SINCLAIR hille architects

Addendum #3

Project Name:	Concordia STEM Seward, NE
Project No.:	16022-05
Date Issued:	May 11, 2018
Bid Date:	Thursday, May 17, 2018

1 Roof Level Plumbing Waste & Vent – Area A.2
1/4" = 1'-0"

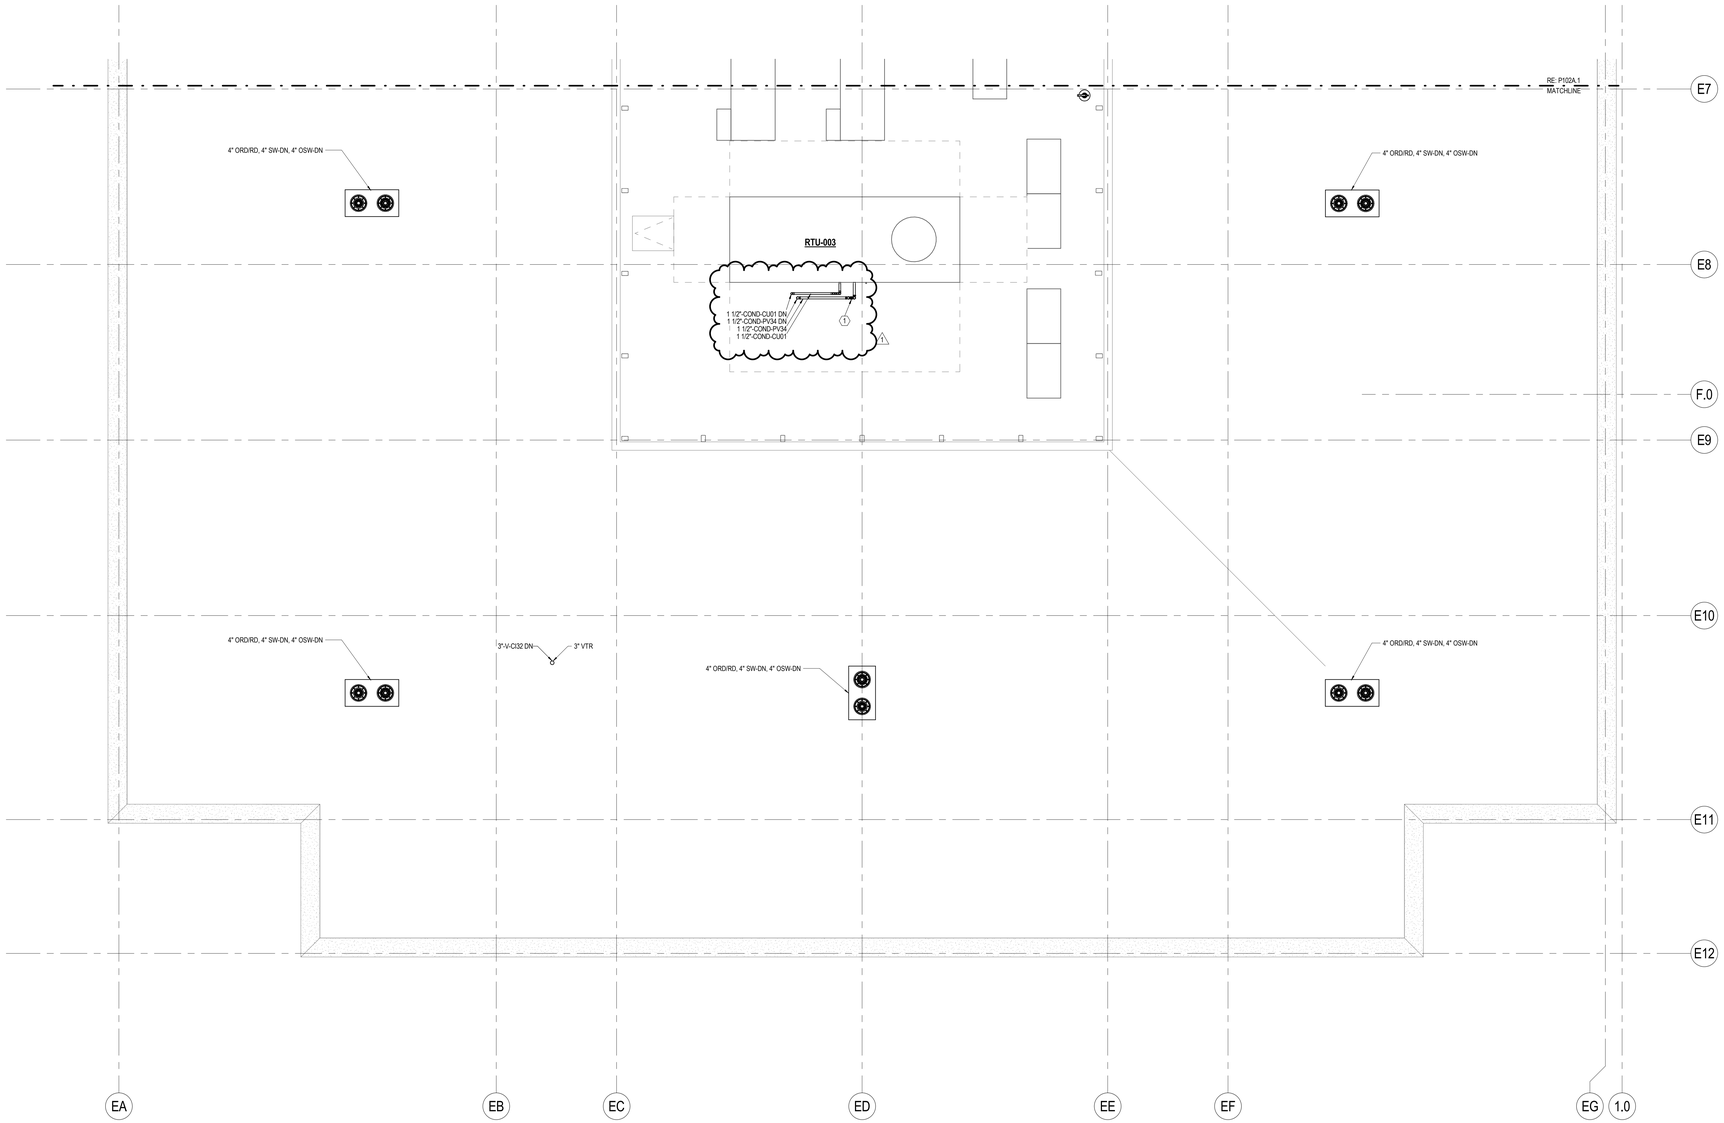
ADD 3-18. Drawing P102A.2. Updated cooling coil condensate drain pipe from RTU-003 on roof to copper. All condensate drain pipe tags updated from “CD” to “COND”.

1 Upper Level Plumbing Waste & Vent – Area B.3
1/4" = 1'-0"

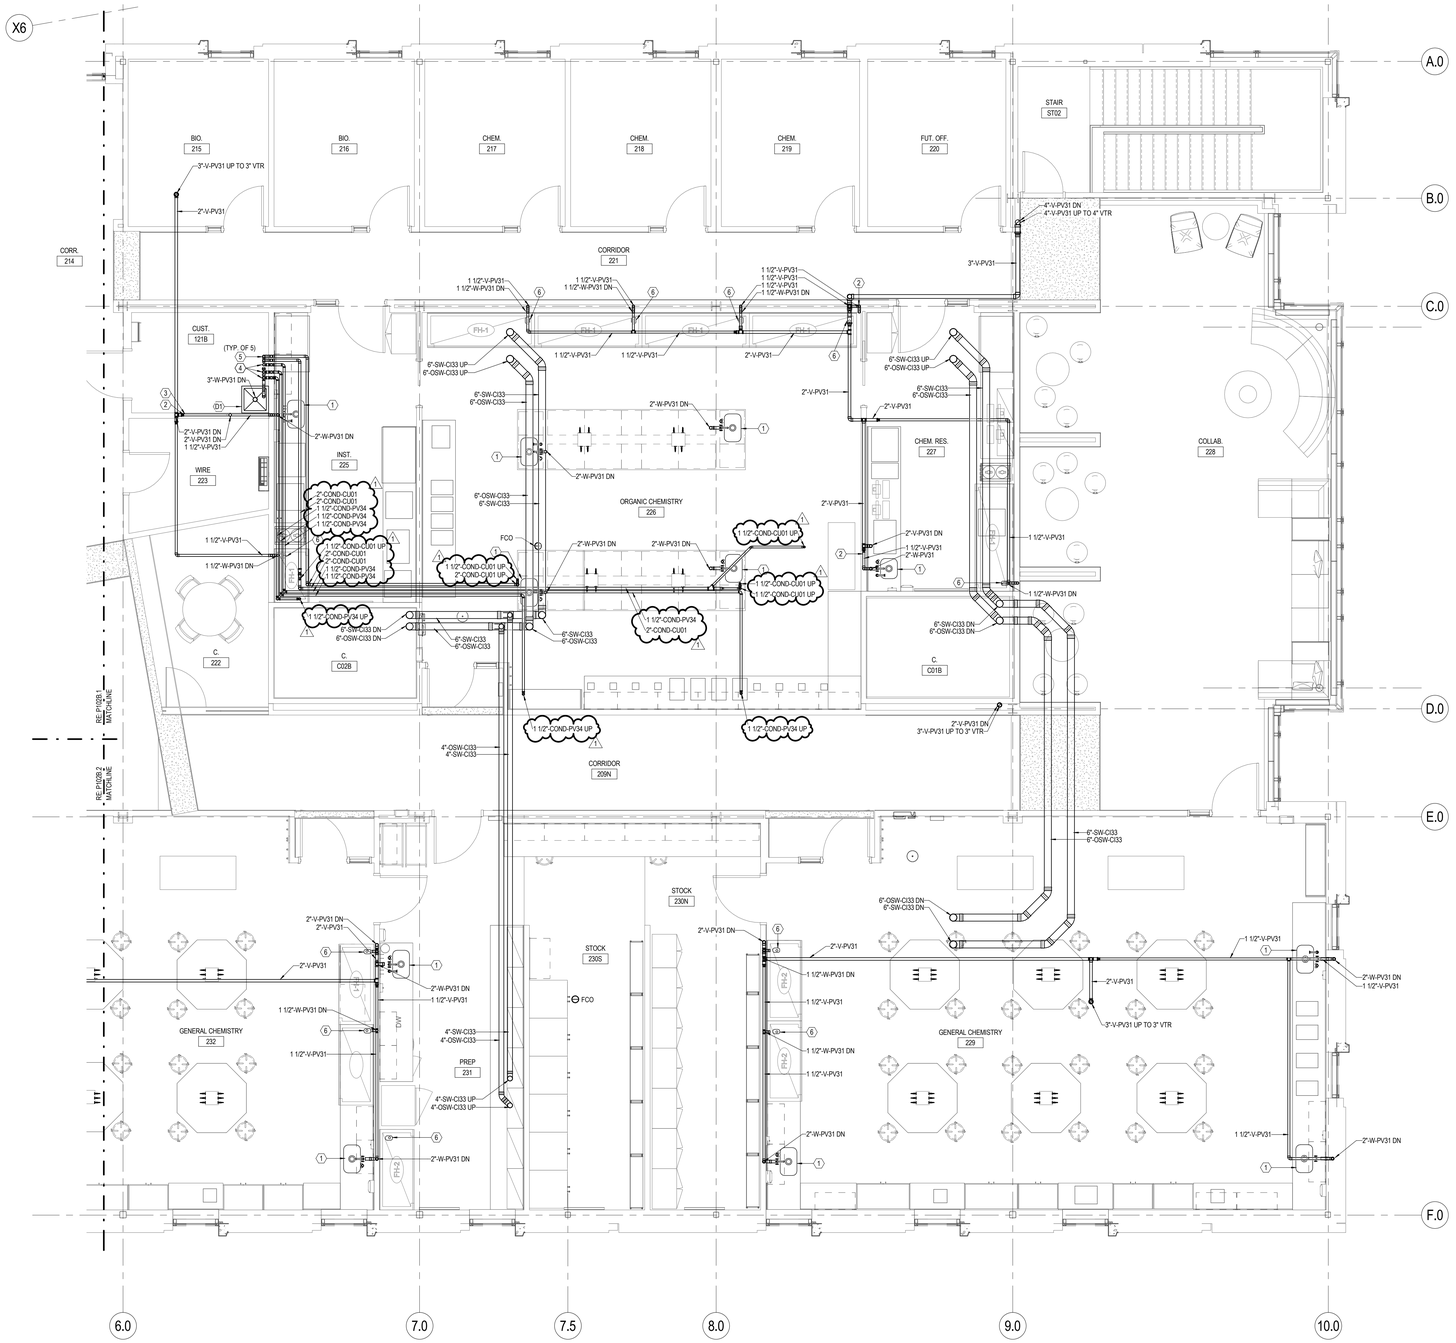
ADD 3-19. Drawing P102B.3. All condensate drain pipe tags updated from “CD” to “COND”.

1 Roof Level Plumbing Waste & Vent – Area B.3
1/4" = 1'-0"

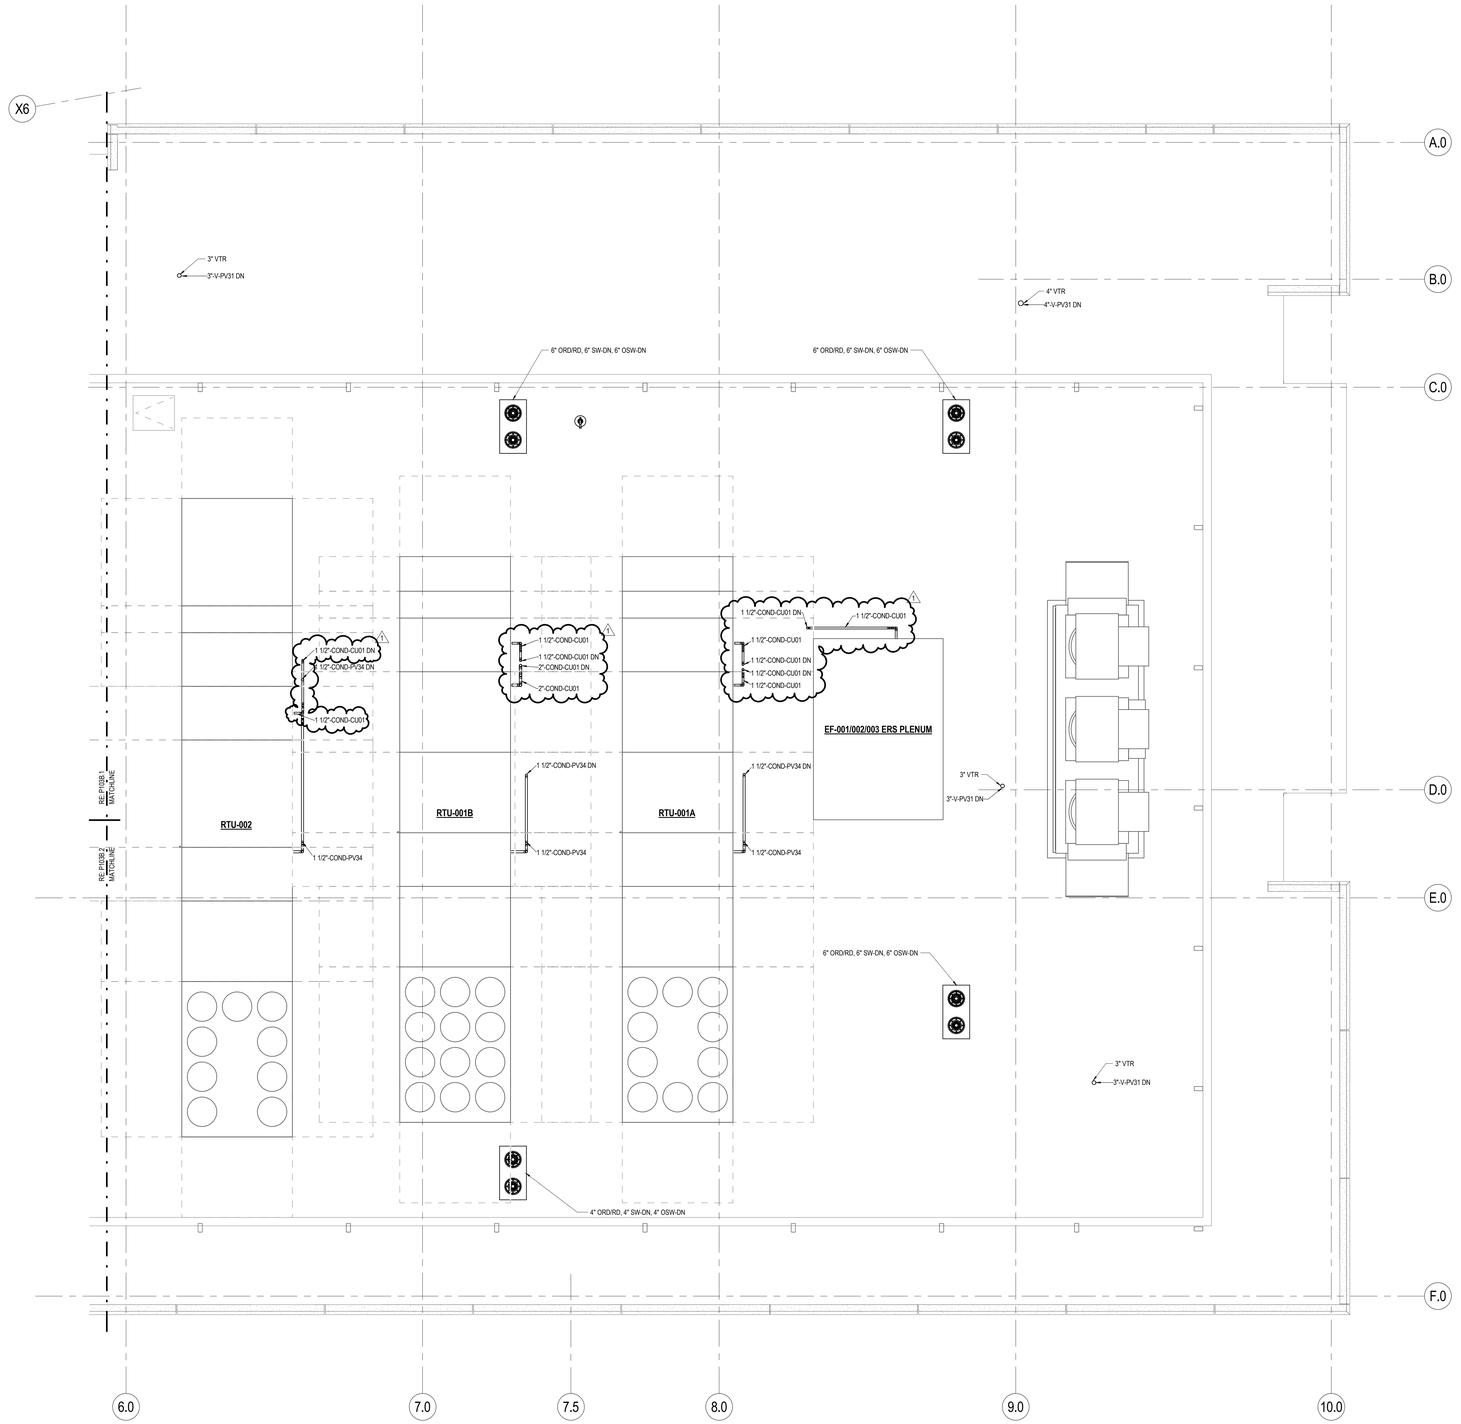
ADD 3-20. Drawing P103B.3. Updated cooling coil and energy recovery condensate drain pipes from RTU-001A, RTU-001B, RTU-002, and EF-001/002/003 ERS Plenum on roof to copper. All condensate drain pipe tags updated from “CD” to “COND”.

1 Lower Level Lighting Plan – Area B.3
1/4" = 1'-0"

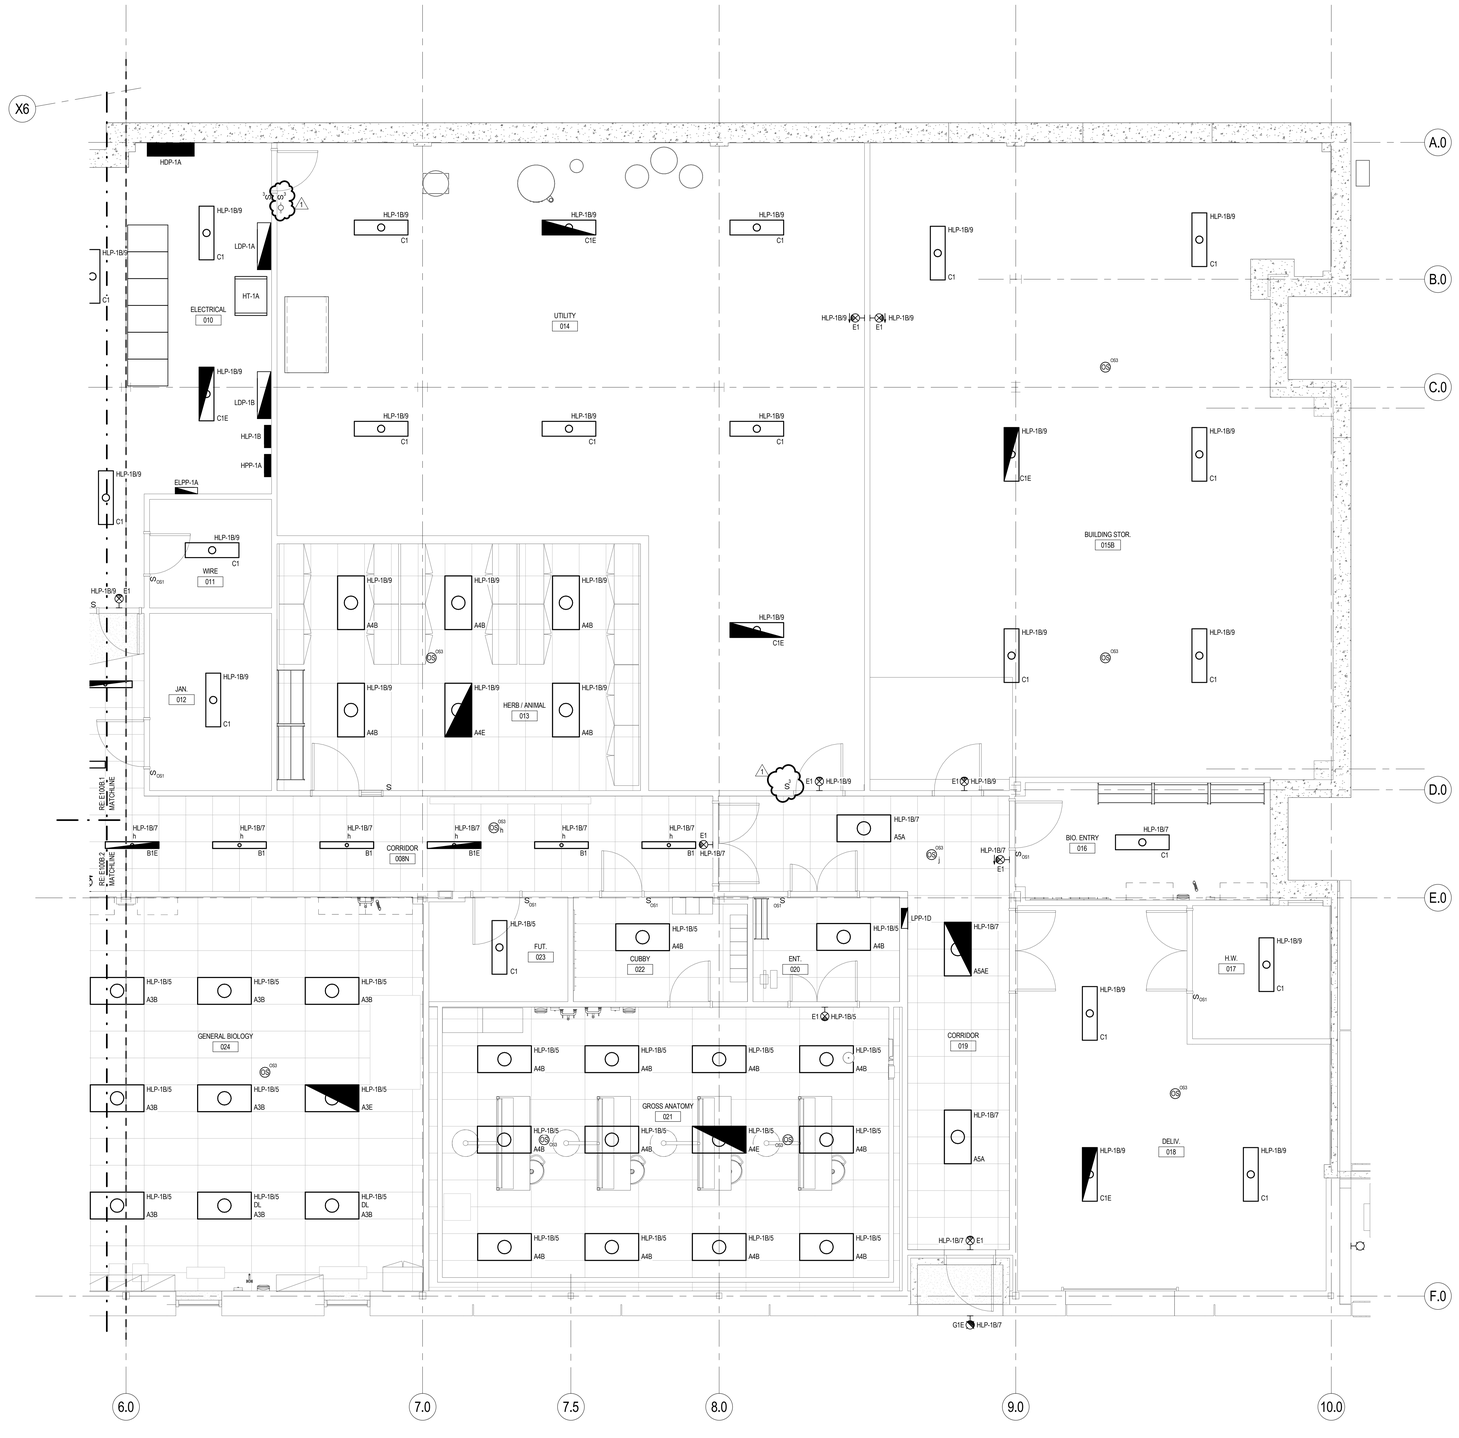
ADD 3-22. Drawing E100B.3 Added three way switching to Utility room 014.

1 Main Level Lighting Plan – Area A.1
1/4" = 1'-0"

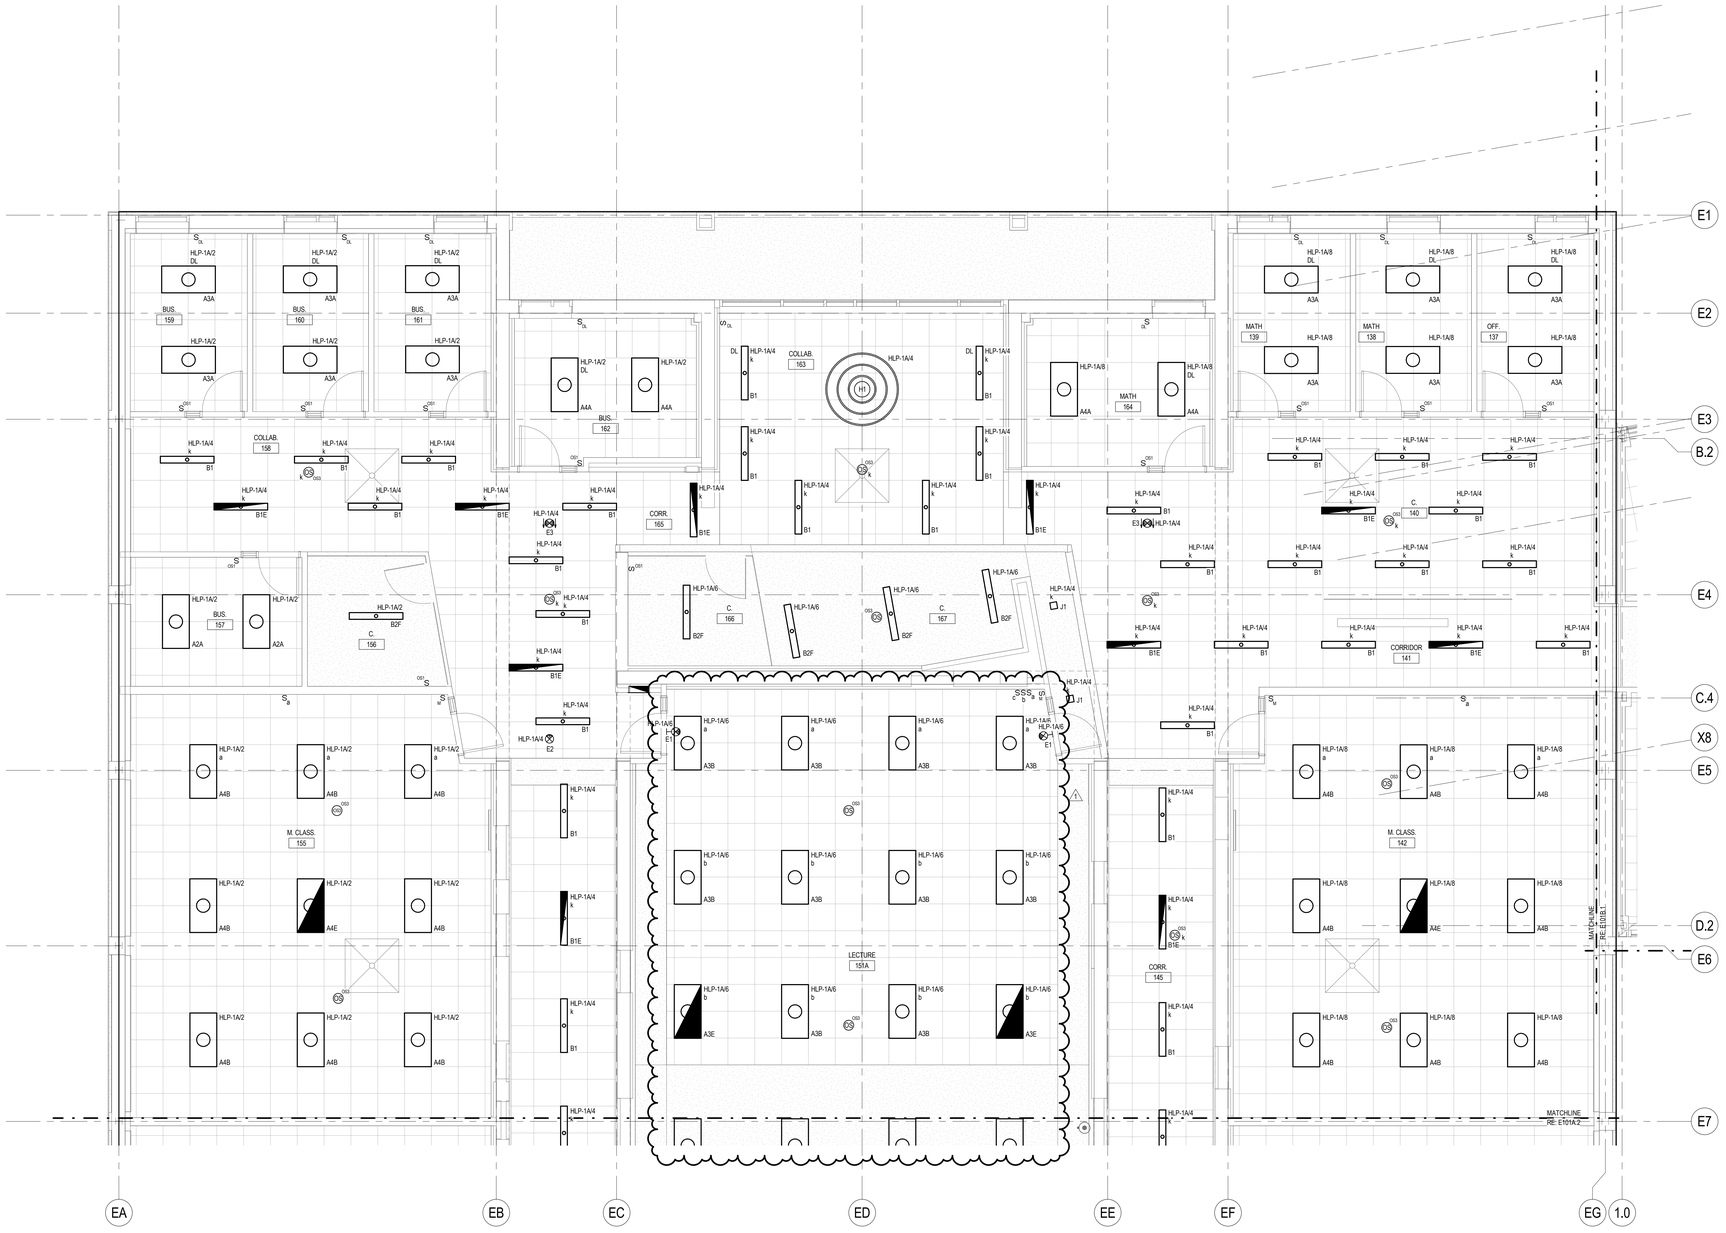
ADD 3-23. Drawing E101A.1, E101A.2. Modified lighting in room 151A.
